CERTIFICATE OF APPROPRIATENESS

Property: 515 Woodland Street, Lot 13, Tract 12, Block 21, Woodland Heights Subdivision. The property includes a historic 1,436 square foot one-story wood frame single-family residence and detached carport situated on a 6,200 square foot (100 x 62) interior lot.

Proposal: Alteration – Addition. Construct a 684 square foot second story atop the rear half of the existing historic structure.

Recommendation: Denial - does not satisfy criteria 1, 4, 8, 9

WEST SIDE ELEVATION

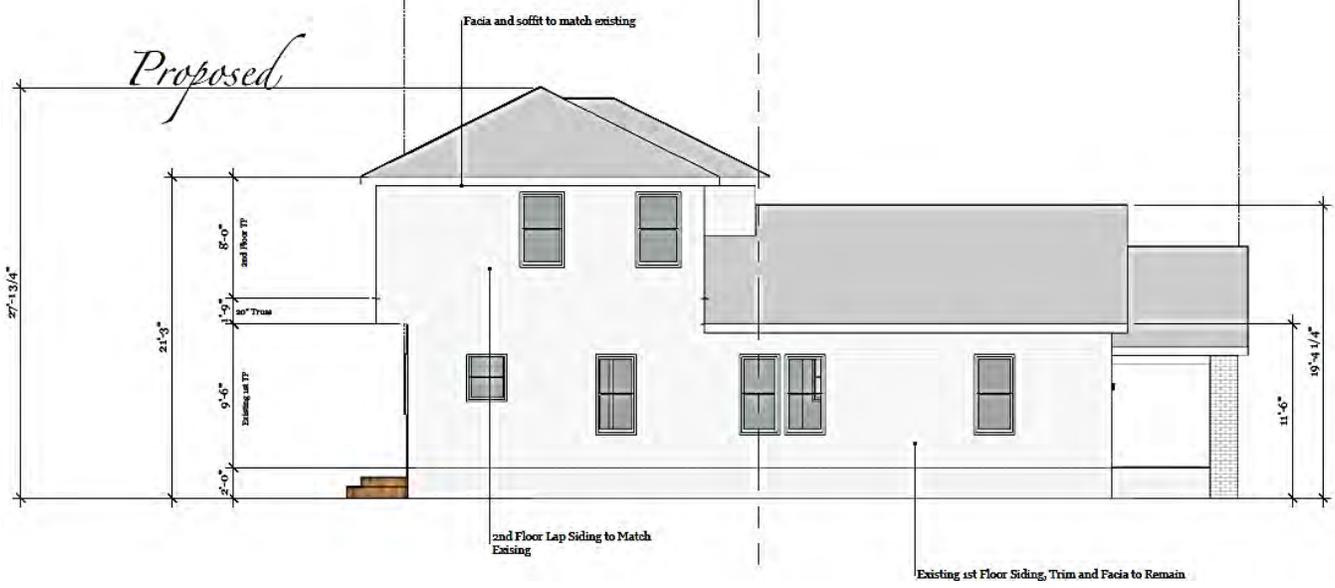
The encroachment of the proposed addition onto 50% of the original structure severely impacts the historic character of this structure and property. The second story addition will encroach 50% onto the existing structure while the rear of rear of the second story extends an additional two feet past the existing rear wall. The proposed second-story addition will also interfere with the roof configuration of the east side bump-out, altering a distinguishing characteristic of this one-story structure.

A solution to help mitigate the alteration of the bump-out roof configuration, would be to flip the proposed addition; having the deeper portion on the west side as opposed to the east side. Insetting the addition on the east and west elevations will also help demassify and the addition and preserve the original eave line.

Constructing a second-story addition atop half of an existing one-story building impairs the essential form and integrity of the existing historic structure. In order to minimize or eliminate the detrimental impacts to the historic form and integrity of the building, the proposed addition should begin farther towards the rear of the property and expand back, not over the existing structure. However, in this situation, a pool is located approximately 5' from the rear wall of the structure, limiting the potential for starting the addition farther back.

EAST SIDE ELEVATION

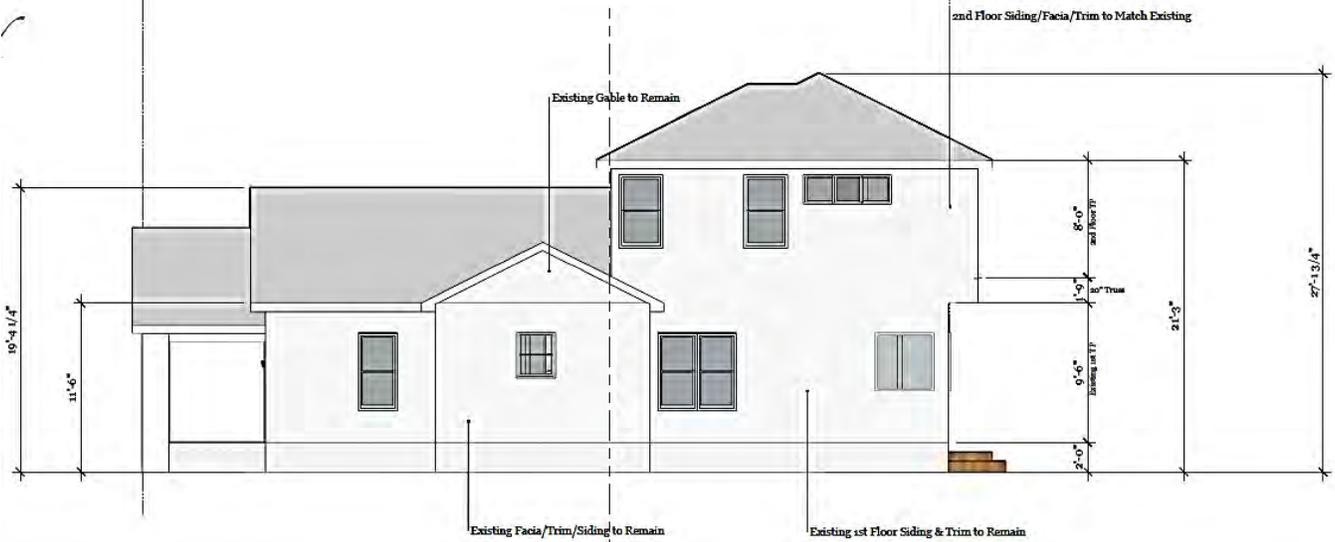
The encroachment of a two-story addition over the rear half of the residence heavily alters the distinguishing character of the historic one-story residence and negatively impacts the structure visually. Additionally, the existing exterior walls (which will support the addition) were not built to support the additional load of a second-story and will have to be reinforced, leading to the potential loss of historic material including the siding and shiplap. The inclusion of a second window on the east elevation will also have a detrimental effect of the framing, siding, and shiplap. In order to maintain the original eave line, the addition should be inset on the east and west sides.
